INSTRUCTION TO SERVICE

ITS: 6898

SECTION:	260 Battery Compartment
WRITTEN BY:	Troy Stutsky
SUBJECT:	Re-torque CS and SS side screen mounting bracket nuts

Figure 1: Locations of hardware that requires re-torque

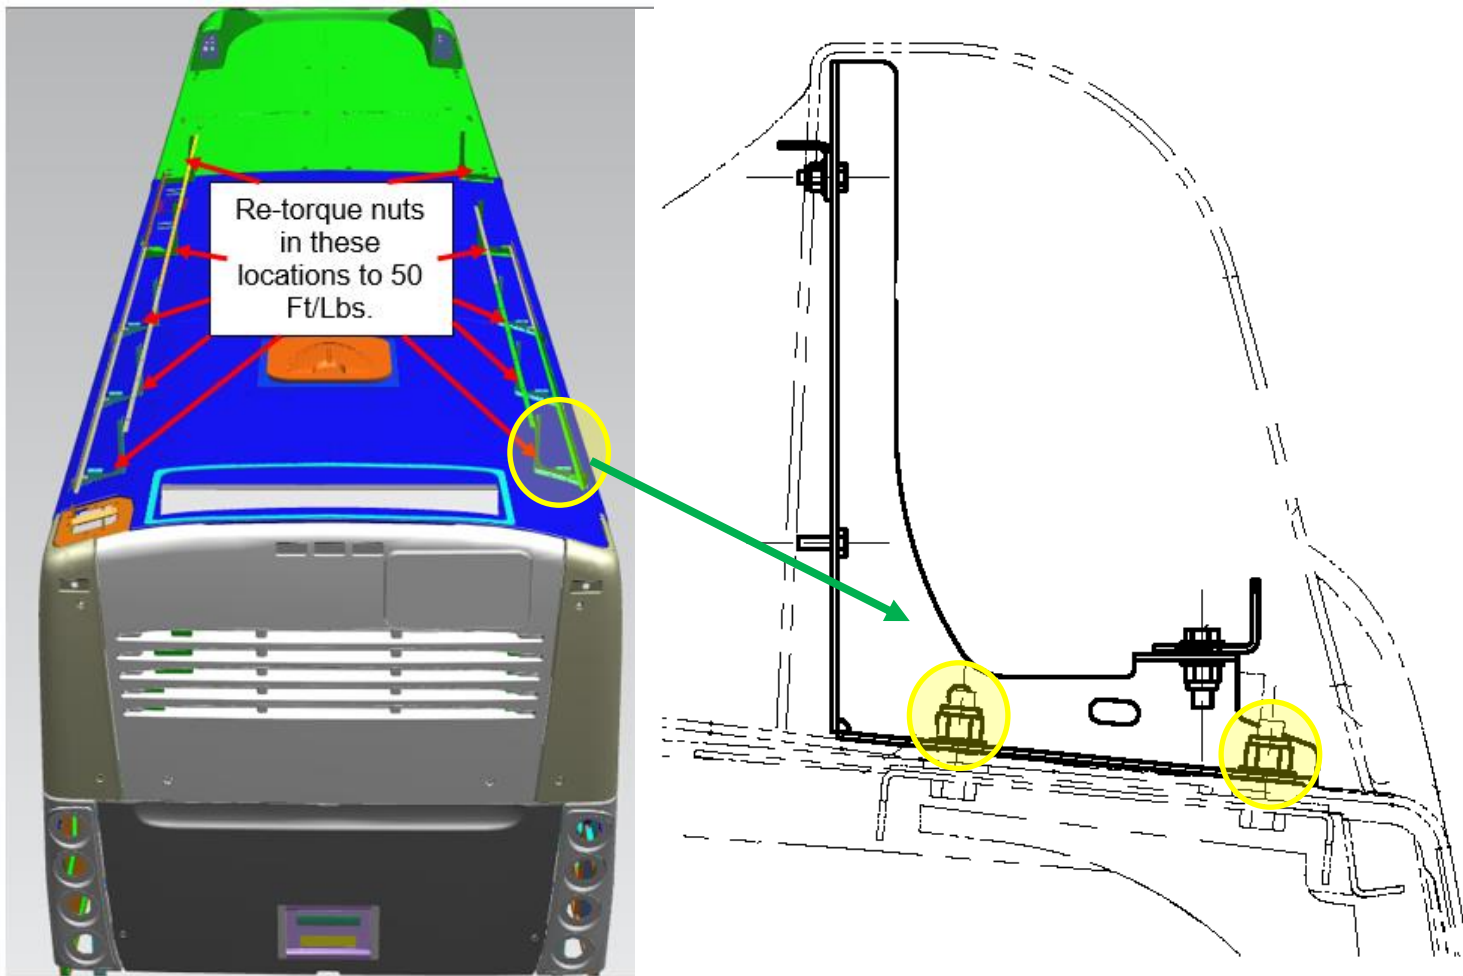
2. On the roof of the bus, re-torque the nuts that fasten the side screen brackets to the roof of the bus to 50 Ft/Lbs using a properly calibrated torque wrench. There are ten locations with two nuts each. Please see Figure 1 for locations.
